ANA5 – Reworking Wiring Harness for Front Seats (Stop Delivery/Recall Campaign)

Revision: This bulletin replaces bulletin Group 9 87/22 ANA5, dated July 15, 2022.

Model Line: **Taycan (Y1A)
Taycan Cross Turismo (Y1B)
Taycan Sport Turismo (Y1C)**

Concerns: **Wiring harness for front seats on vehicle side**

Installation position of wiring harness for front seat (shown on front left seat)

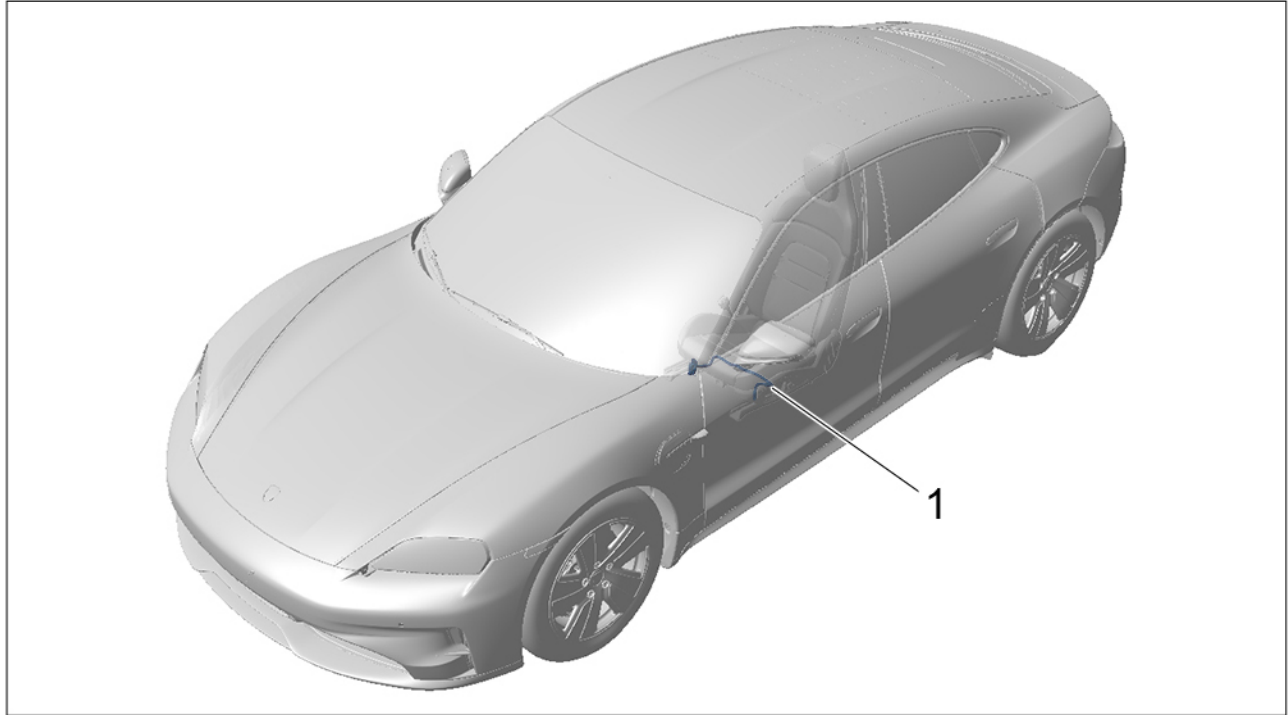
Information: **There is a possibility that the protective fabric hose for the front seat wire harness on the affected vehicles will be damaged longitudinally when adjusting the seat and can then be pulled into the drive spindle for seat adjustment.**

This can block the seat adjustment, damage the wiring harness and activate the airbag warning light in the instrument cluster. In rare cases, the occupant protection system may be impaired.

Action required: Check protective tube for fabric, wiring harness and drive spindle on the front seats, rework them and repair them if necessary.

Drive spindle for seat fore-and-aft adjustment

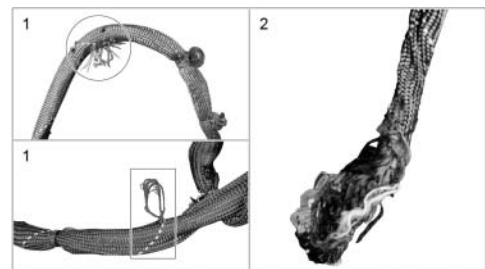
- Work Procedure: 1 Remove left and right front seats. ⇒ *Workshop Manual '720119 Remove and install front seat'*
- 2 Check drive spindle for seat fore-and-aft adjustment at the left ⇒ *Drive spindle for seat fore-and-aft adjustment -1-* and right ⇒ *Drive spindle for seat fore-and-aft adjustment -2-* on **both front seats** for trapped fibres from the protective tube for fabric.

If the drive spindle is contaminated with fabric fibres, remove them using a suitable tool.
Then continue with: ⇒ *Technical Information '720119 Checking protective tube for fabric and wiring harness'*

Protective tube for fabric and front-seat wiring harness

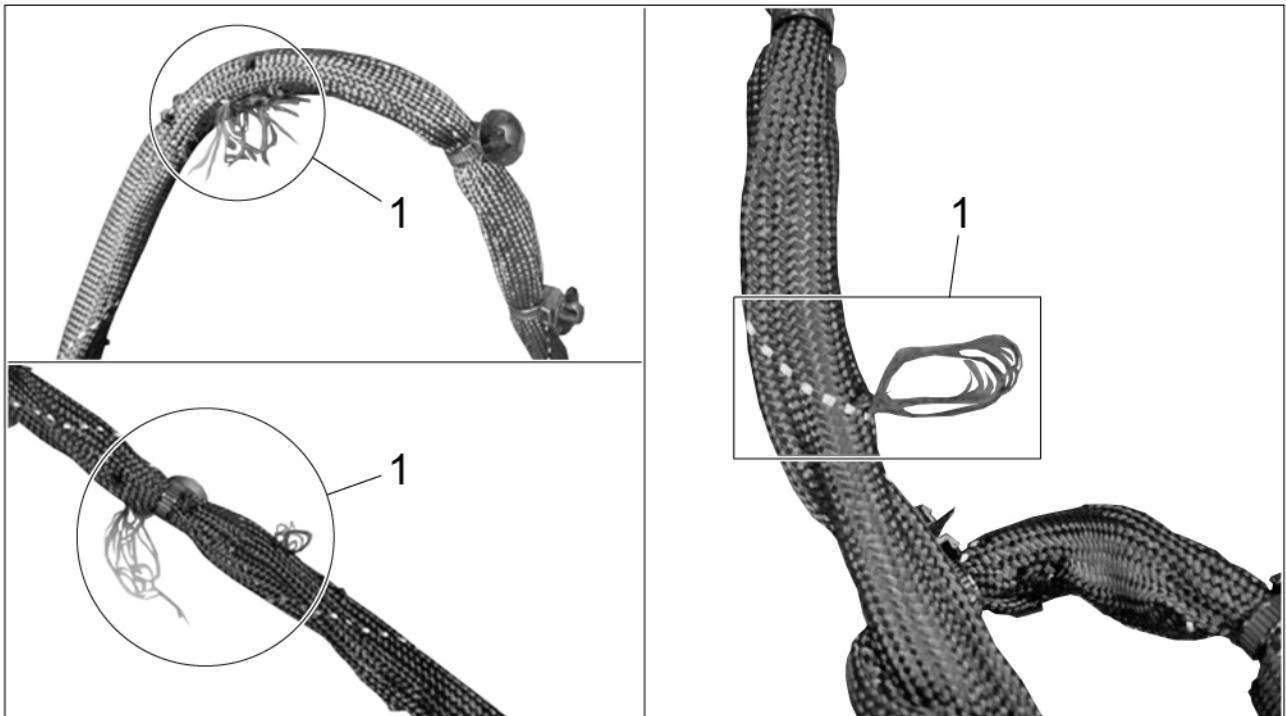
Work Procedure: 1 Check protective tube for fabric on the front seat wire harness for loose fibres ⇒ *Protective tube for fabric and front-seat wiring harness -1-* or damage ⇒ *Protective tube for fabric and front-seat wiring harness -2-*.

Assessment	Action
There are no loose fibres or damage visible on the protective tube for fabric.	Rework wiring harness, continue with section: ⇒ <i>Technical Information '720119 Reworking wire harness for front seats'</i>

<p>There are loose fibres visible on the protective tube for fabric and the electric wiring harness is not damaged.</p>	<p>Remove loose fibres and rework wiring harness. Continue with section: ⇒ <i>Technical Information '720119 Reworking wire harness for front seats'</i></p>
<p>There is damage visible on the protective tube for fabric and the electric wiring harness.</p>	<p>Repair electric line, remove loose fibres from the fabric protective tube and rework wiring harness. Continue with section: ⇒ <i>Technical Information '720119 Repair wire harness'</i></p>

Loose fibres

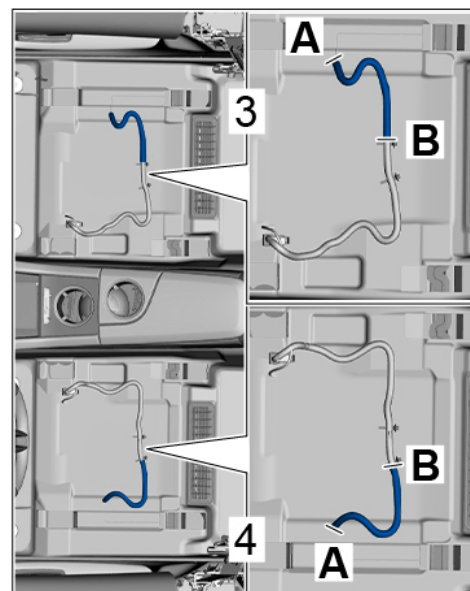
Work Procedure: 1 If \Rightarrow *Loose fibres -1-* there are loose fibres on the protective tube for fabric, carefully remove these using a suitable tool.

- 2 Tightly wrap the wiring harness on the front right ⇒ *Reworking wire harness -3-* and left seat, ⇒ *Reworking wire harness -4-* including the protective tube for fabric, between the outlet opening on the carpeting ⇒ *Reworking wire harness -A-* and the first fastening clip on the seat frame ⇒ *Reworking wire harness -B-*. The textile fabric tape should overlap by approx. 1/3.
